Trestain 4.1-3  
Appl. No. 10/820,690  
Amdt. dated November 16, 2004  
Reply to Office Action of August 12, 2004

**AMENDMENTS TO THE DRAWINGS**

FIG. 4

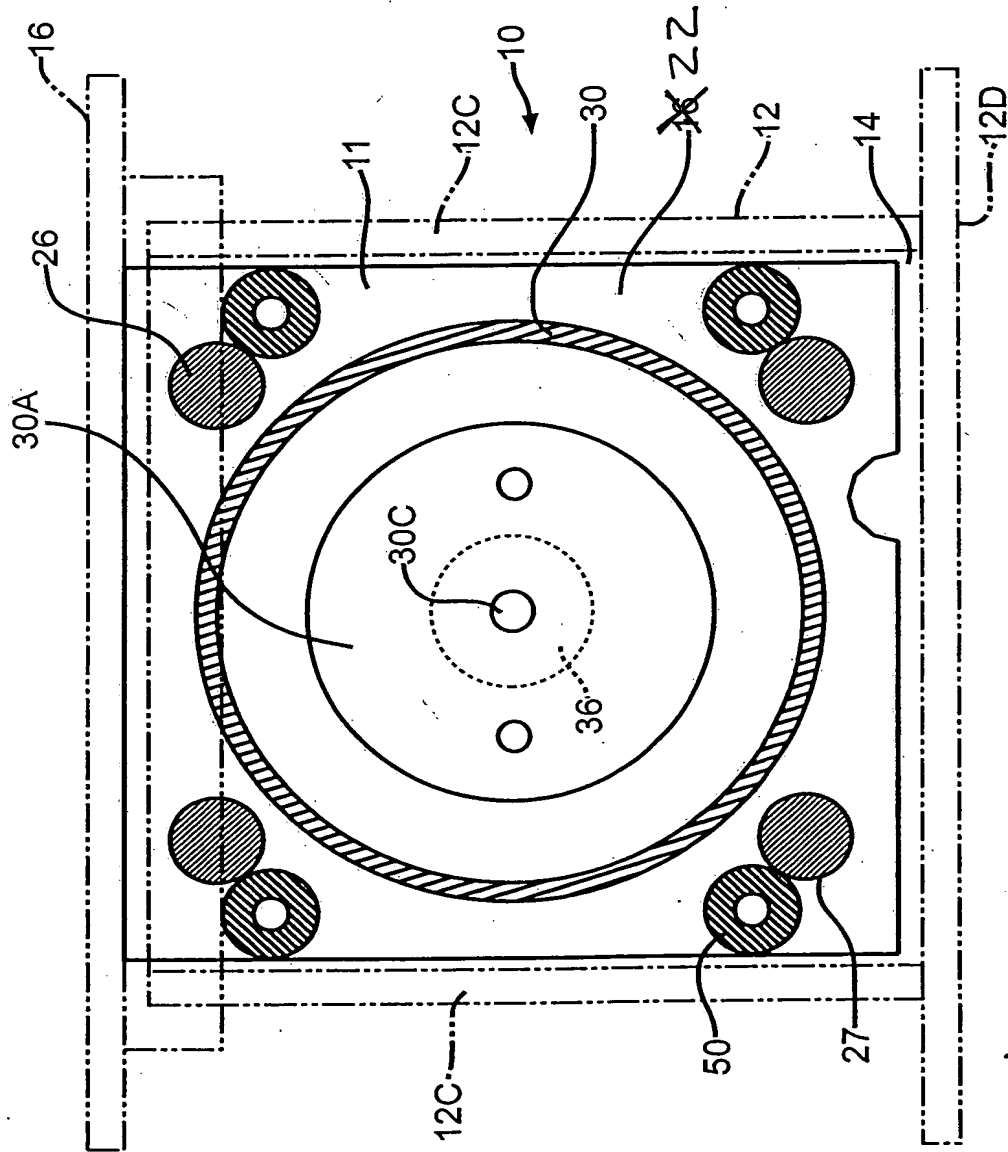
The inventor and his attorney would like to respectfully correct Examiner Bidwell's statement that "the drive plate and conveyor plate are the same and the disclosure is the same regarding their locations". Figure 4 incorrectly labels the drive plate as reference numeral 16 rather than reference numeral 22. An amendment to the Figure 4 is included herewith to correctly identify the drive plate with reference numeral 22. The differences of the drive plate 22 and the conveyor plate 16 are discussed in the specification of the application and shown in the

The attached drawing sheets include a change to Figure 4 and Figure 5. In Figure 4, the lead line for the drive plate is incorrectly labeled with reference numeral 16. Figure 4 has been amended to change the reference numeral for the drive plate to 22.

FIG. 5

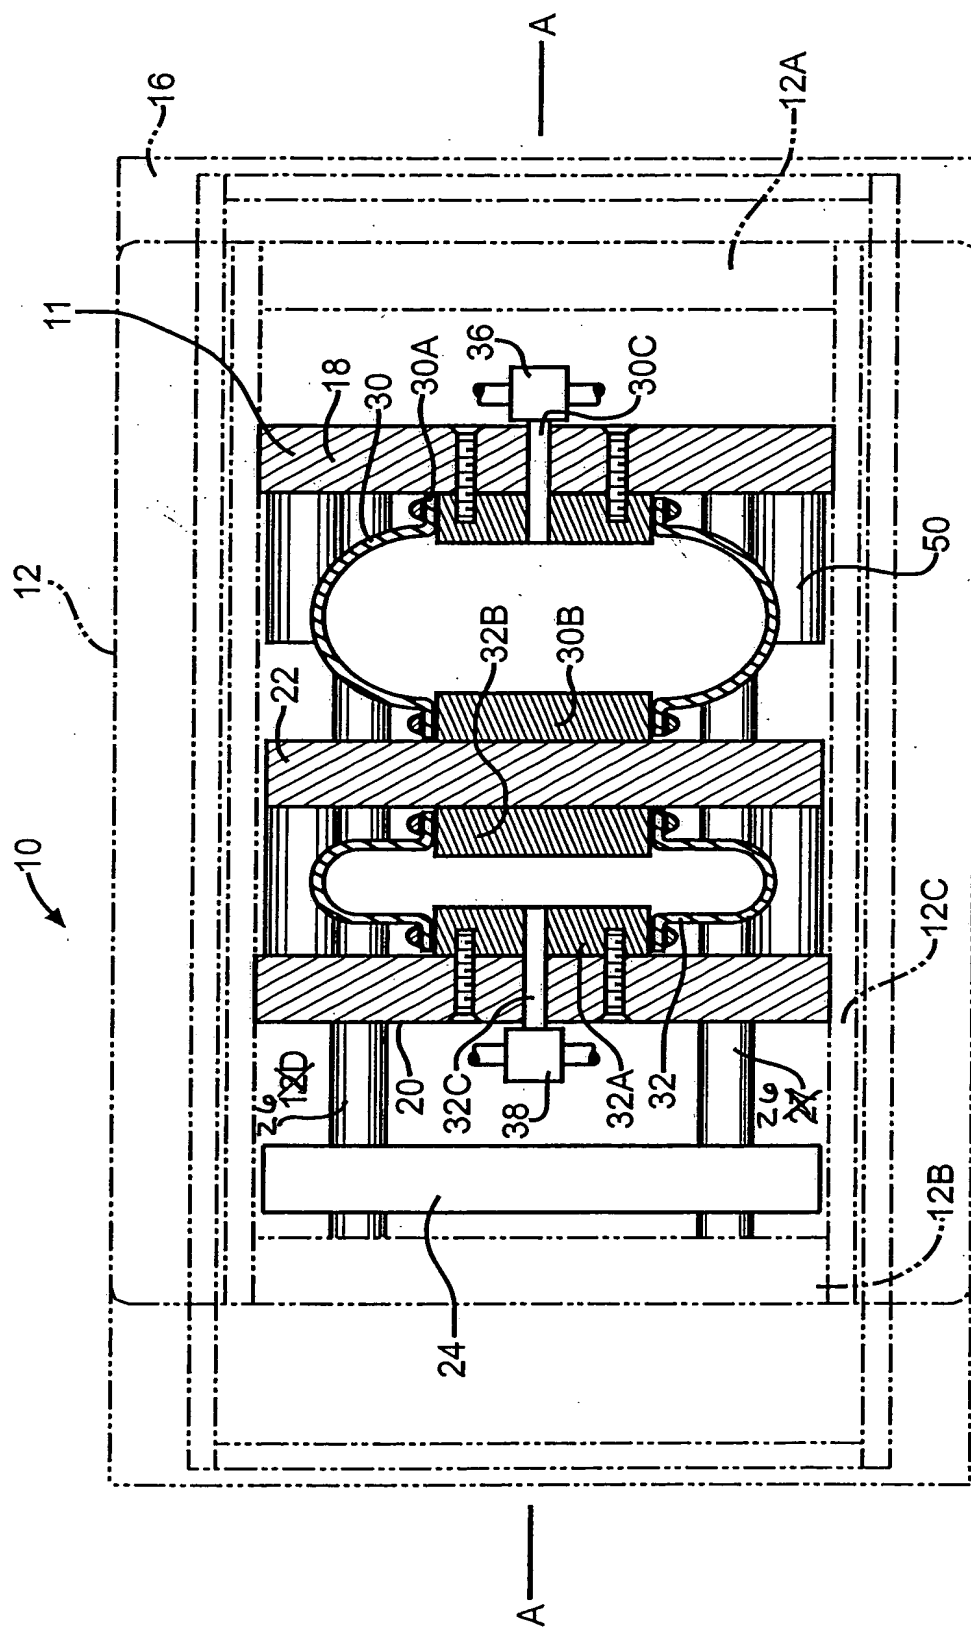
In Figure 5, one of the upper guide rods are incorrectly labeled with reference numeral 27 which corresponds to the lower guide rods. Figure 5 has been amended to correctly label both the upper guide rods with the reference numeral 26. In addition, the reference numeral 12D which corresponds to the bottom wall of the housing has been removed.
